Sheet: /
File: 500219-B_PCBA POWER.kicad_sch

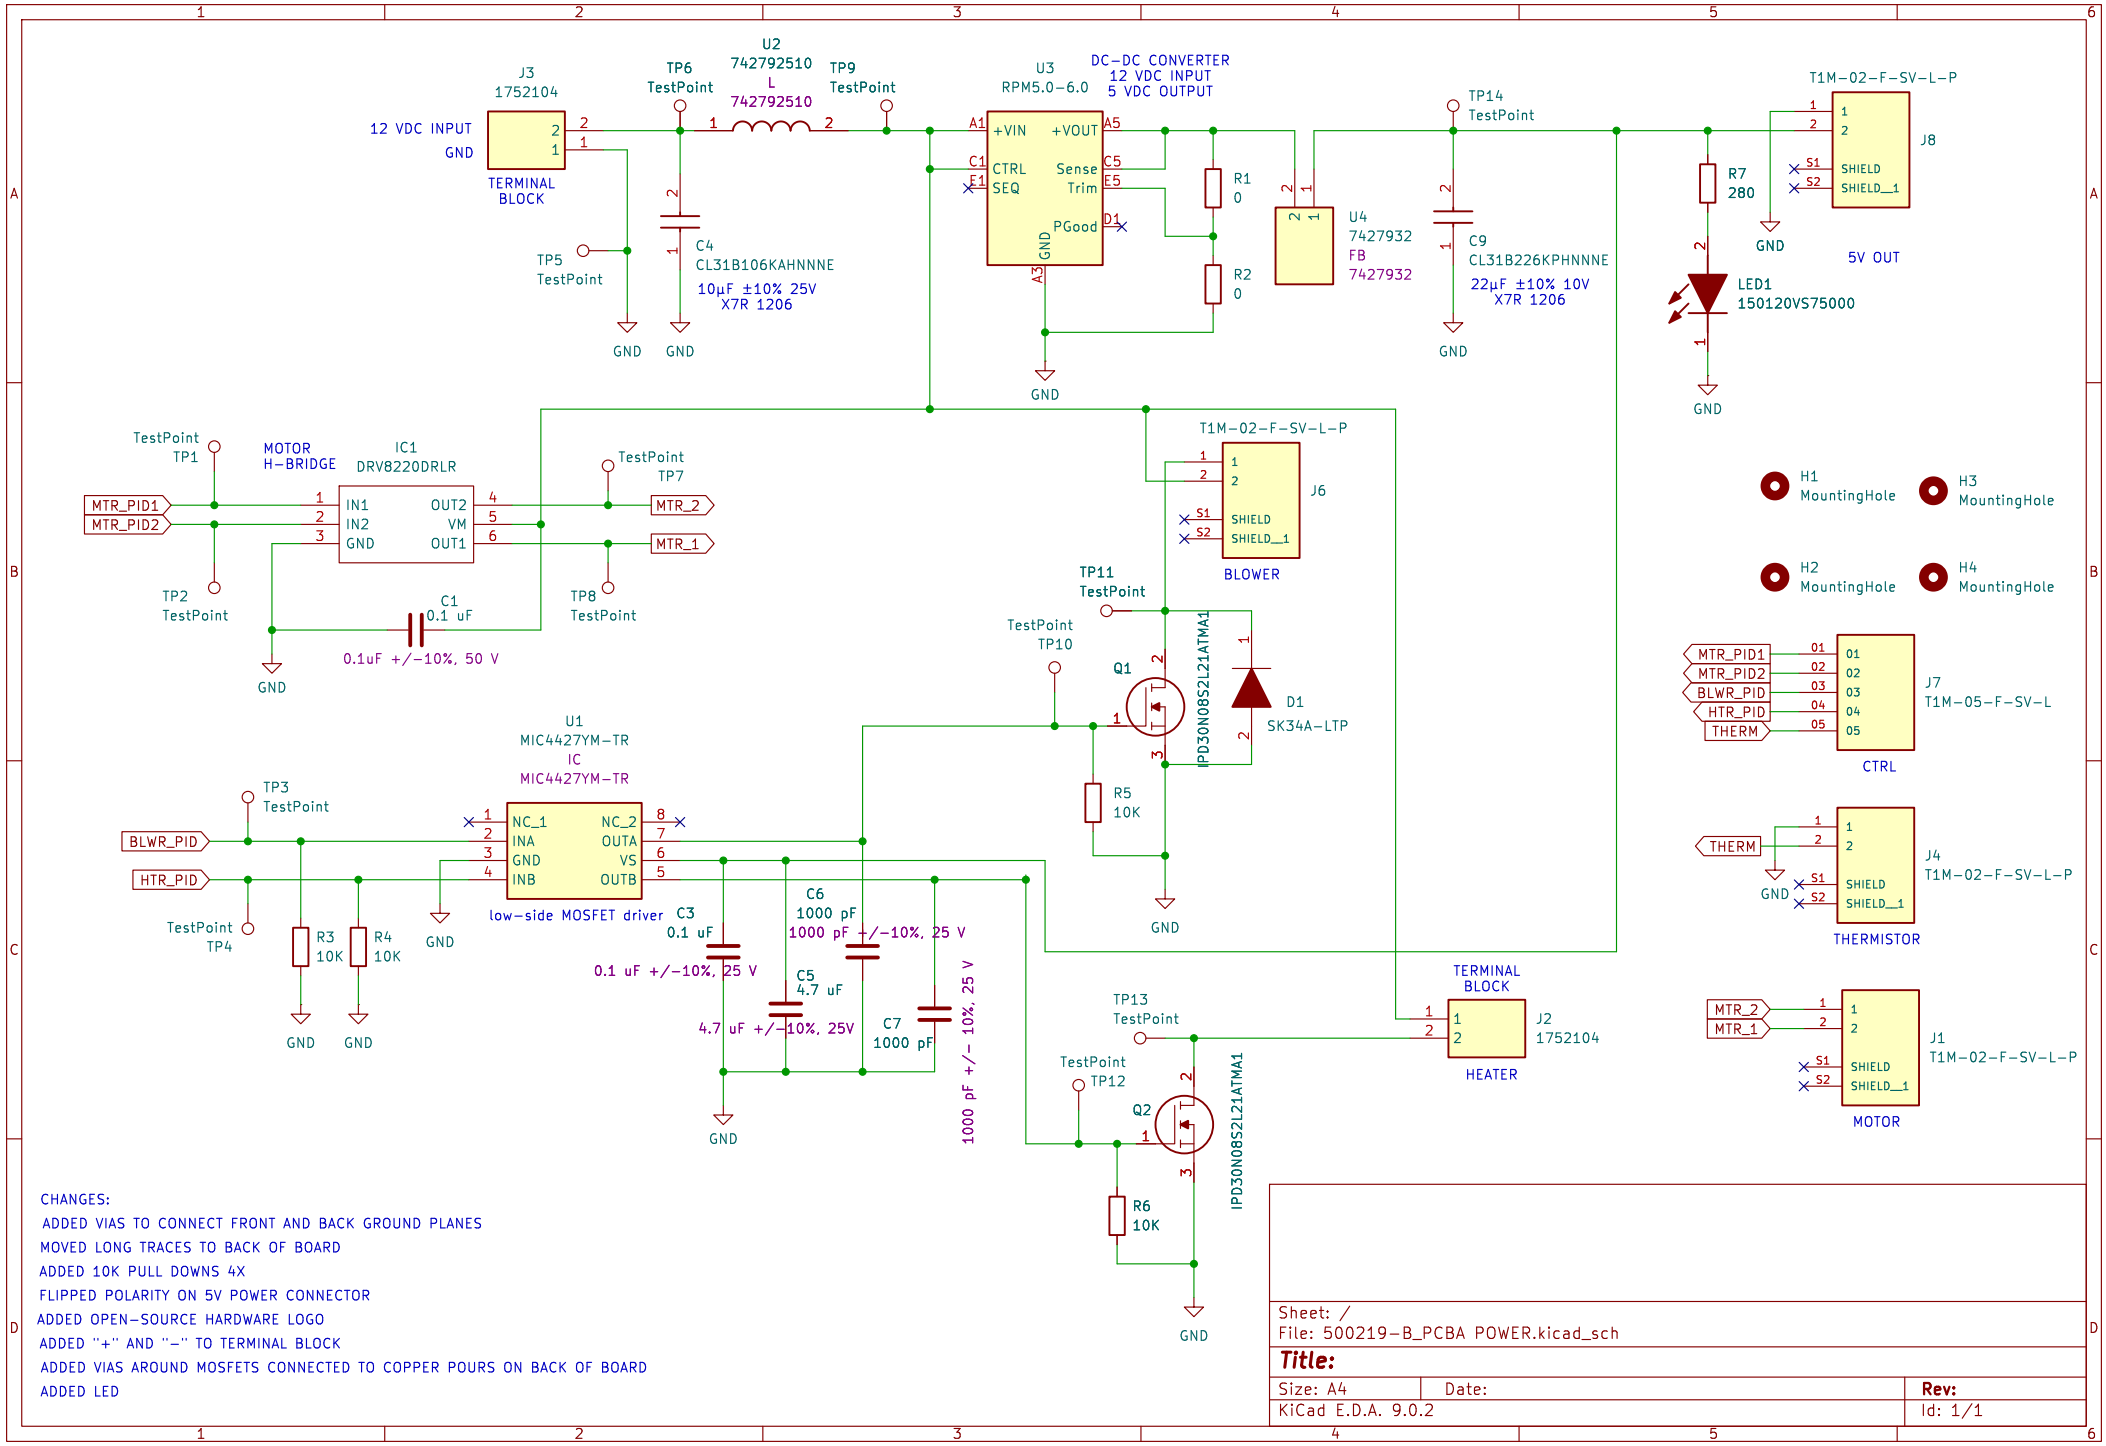
CHANGES:
ADDED VIAS TO CONNECT FRONT AND BACK GROUND PLANES
MOVED LONG TRACES TO BACK OF BOARD
ADDED 10K PULL DOWNS 4X
FLIPPED POLARITY ON 5V POWER CONNECTOR
ADDED OPEN-SOURCE HARDWARE LOGO
ADDED "+" AND "-" TO TERMINAL BLOCK
ADDED VIAS AROUND MOSFETS CONNECTED TO COPPER POURS ON BACK OF BOARD
ADDED LED
